UNITED STATES PATENT AND TRADEMARK OFFICE

APPLICATION NO.	FILING DATE	FIRST NAMED INVENTOR	ATTORNEY DOCKET NO.	CONFIRMATION NO.
09/408,437	09/29/1999	TAKASHI TAKAHASHI	2271/60102	4050

Office Action Summary

DETAILED ACTION

FIG. 4

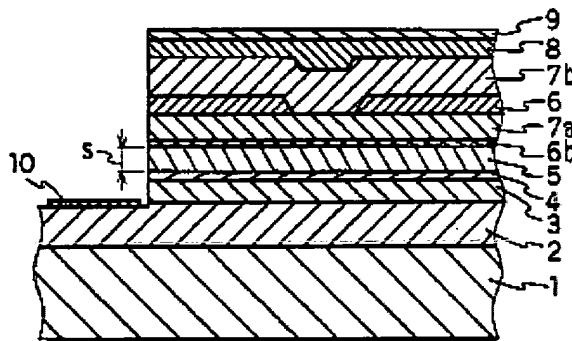
In figure 4 Tanaka et al discloses a semiconductor laser having a substrate (1), an active layer (4), cladding layers (3,5) and an absorbing layer (6b). The absorbing composed of InGaN provides self-oscillation, as disclosed in column 18 lines 1-35. In column 26 lines 30-42 Tanaka et al discloses a general expression for the

semiconductor layers of figure 4 of AlGaInN, where N may be replaced in part or in whole by As and/or P.

In figure 4 Tanaka et al discloses a semiconductor laser having a substrate (1), an active layer (4), cladding layers (3,5) and an absorbing layer (6b). The absorbing provides self-oscillation composed of InGaN, as disclosed in column 18 lines 1-35. In column 26 lines 30-42 Tanaka et al discloses a general expression for the

semiconductor layers of figure 4 of AlGaInN, where N may be replaced in part or in whole by As and/or P.

Tanaka et al does not disclose an intermediate layer having no N.

FIG. 8

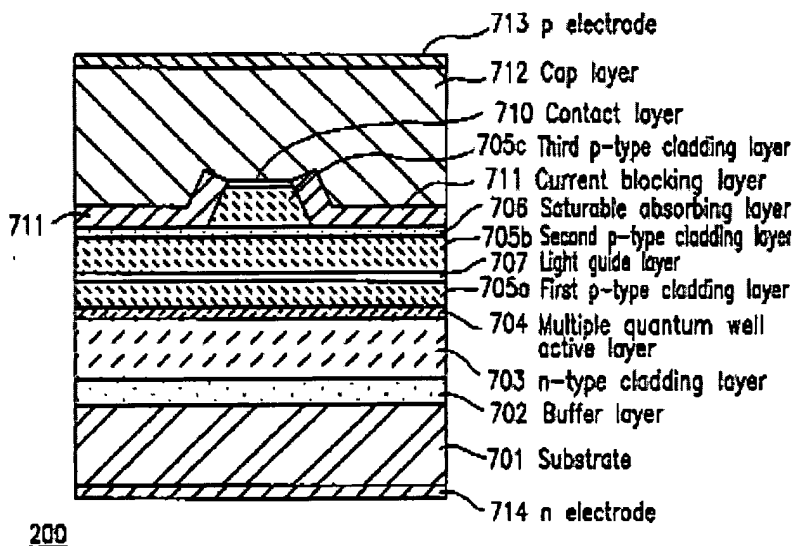
In figure 8 Kidoguchi et al discloses a semiconductor laser having an absorbing layer (706), which provides self-pulsation. Light guiding layer (707) for increase light confinement in the absorbing layer composed of AlGaInP is provided between the cladding layer and the absorbing layer, where it contains less Al concentration than the cladding and contains no N, as described in column 10 lines 10-65.

Therefore, it would have been obvious to one of ordinary skill in the art to use the teaching of Kidoguchi et al in the device of Tanaka et al because it would increase the light confinement in the absorbing layer to cause self-pulsation.
